Re: Albion Park Quarry – Stage 7 (SSD-10369) RFI 8 and RFI9

I refer to the Department's Requests for Information RFI8 and RFI9 dated 11 August and 14 September 2023 respectively. RFI8 sought additional information in relation to the proposed final landform and associated water balance and site access, as well additional mitigation measures to ameliorate heritage-related impacts on "The Hill Complex." RFI9 sought a response to the advice provided by WSP dated 13 September 2023. The following provides a response to the matters raised.

FINAL VOID PIPE OUTLET – HYDROLOGICAL REVIEW (RFI#2 and RFI#8)

Figure A
FINAL LANDFORM
CROSS-SECTIONS

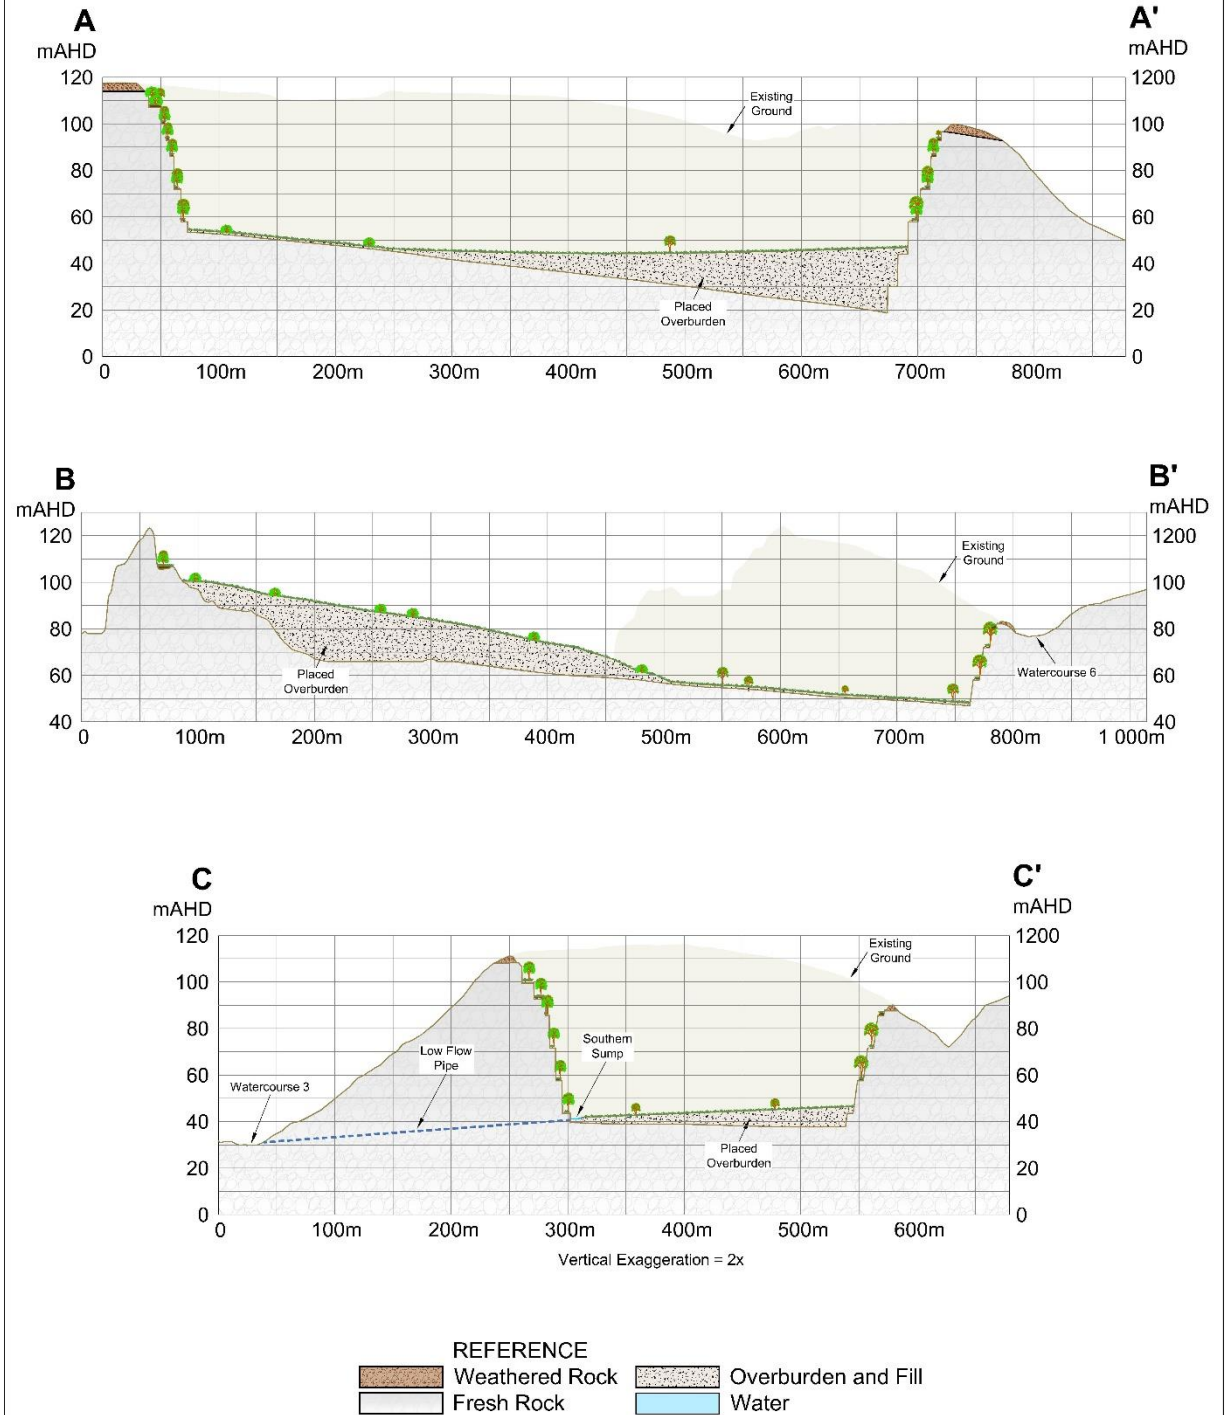
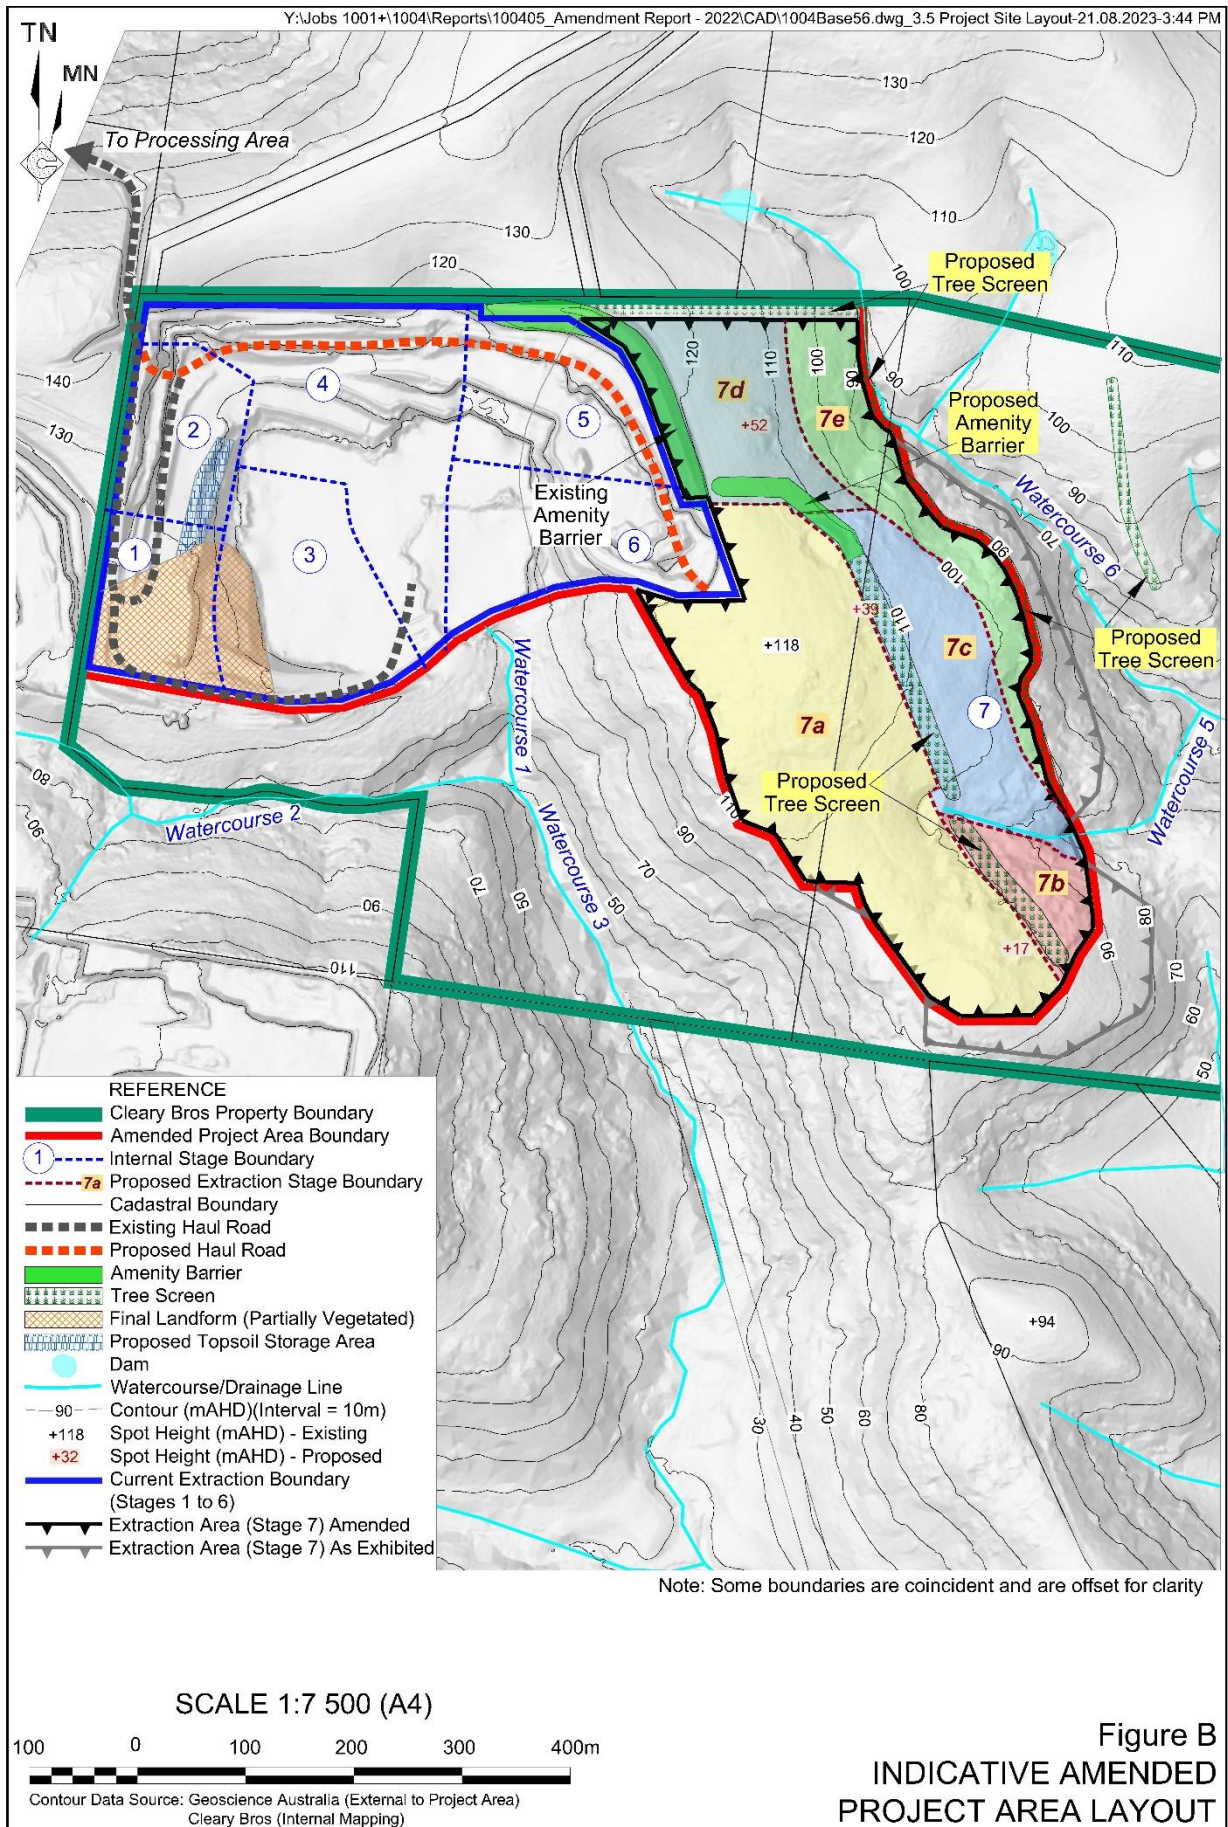
The Department has identified that the final landform cross section included in the amended project description represents the horizontal distances incorrectly, i.e. the pit floor in cross section C is 500m wide. The Department requests that the cross-sections are updated with the correct scaling.

Figure A presents the final landform sections with the correct scale.

Figure 1: Indicative Final Landform with Outlet Pipe (Source: RWCorkery & Co)

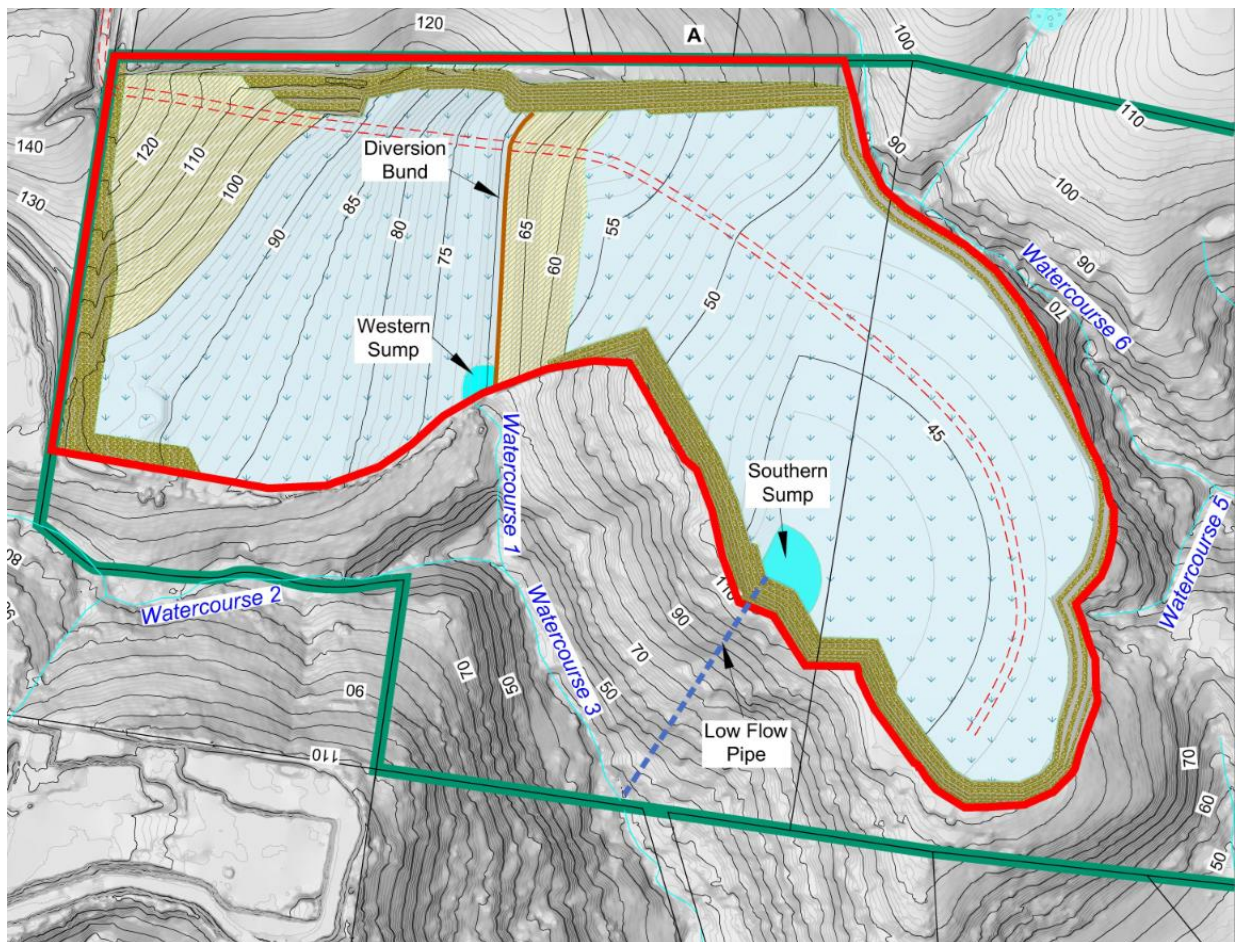
SEEC has been commissioned by Cleary Bros (via RW Corkery & Co) to undertake a hydrological review of a proposed pipe outlet from the final void at the Albion Park Quarry Extension – Stage 7. The response will be used to respond to two Requests For Additional Information (RFI#2 and RFI#8) from the NSW Department of Planning and Environment.

It is anticipated at the end of the proposed Stage 7 of the quarry life, that a final void will be formed. The void is expected to be at least 80-90m deep relative to an overflow location, therefore the void will trap rainfall/runoff. In order to prevent the void ponding water, it is proposed to undertake earthworks and fill a portion of the void to create a low spot centrally located in the western section of Stage 7. A pipe will be bored with a slight downslope from the void to an adjacent creek (Watercourse 3) providing a free draining outlet. The Department of Planning and Environment is seeking additional details on the proposal to better understand how the pipe may impact the hydrological regime.

The proposed route of the pipeline is provided in Figure 1.

Figure 27: Post Stage 7 Western sump, 10% AEP, critical storm.

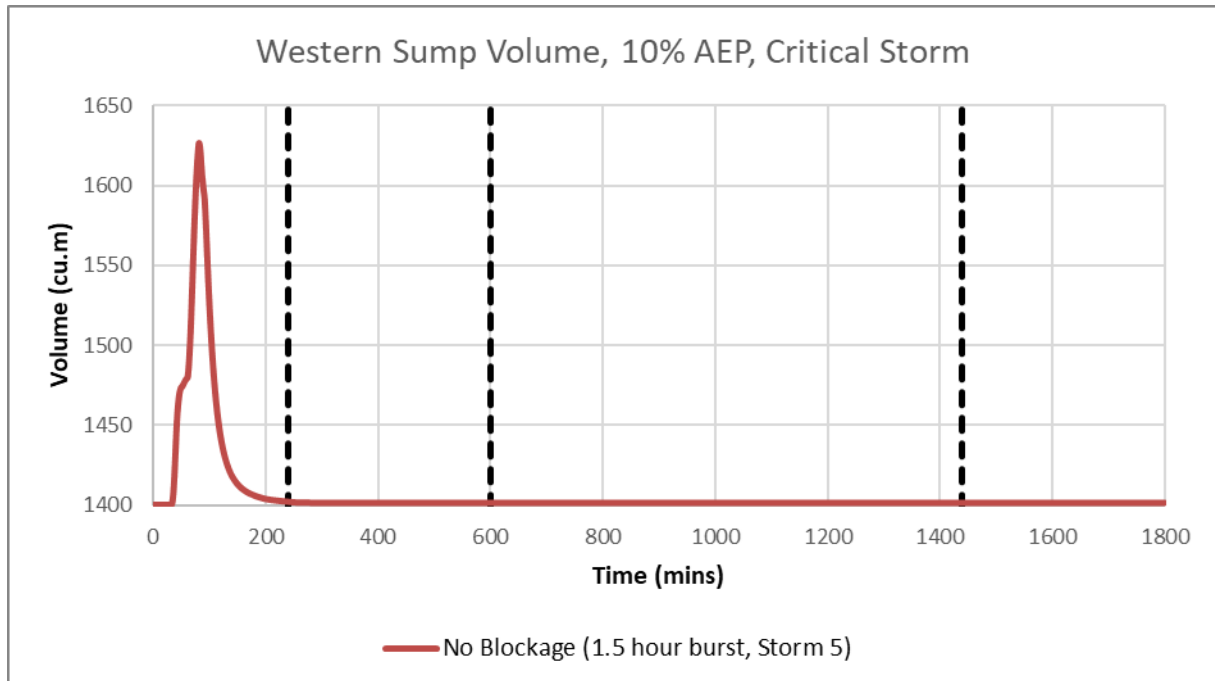
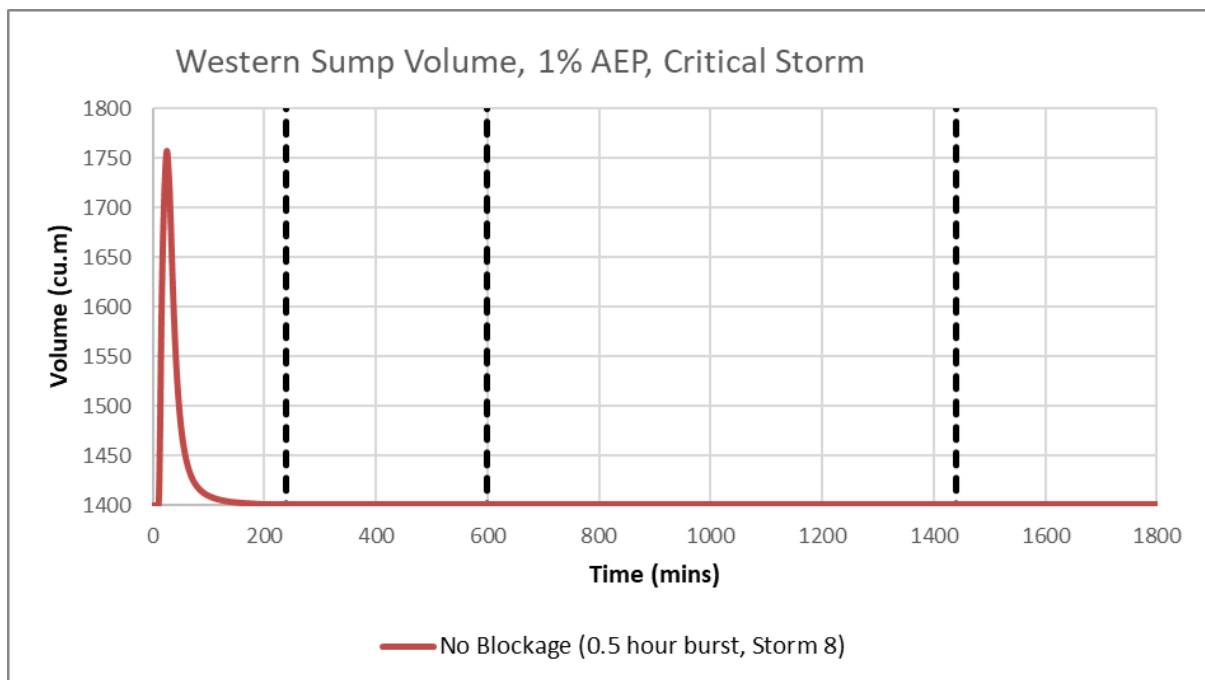
- *Tabulated final landform water balance that provides surface water inflows for a 1% AEP and 10% AEP events*
- *Estimated sizes of the western and southern sumps at 4 hours, 10 hours, and 24 hours during both a 1% and 10% AEP event assuming the proposed pipeline is draining effectively*
- *Estimated size of the southern sump at 4 hours, 10 hours, and 24 hours during a 1% and a 10% AEP event assuming the pipeline is not draining any water.*

The fluctuation in stored water volume in the Post Stage 7 Western sump throughout the 10% AEP and 1% AEP critical storm events are shown in Figure 27 and Figure 28, respectively. The graphs also show additional vertical axes at 4, 10 and 24 hours. Note that the volume will vary depending on the design storm.
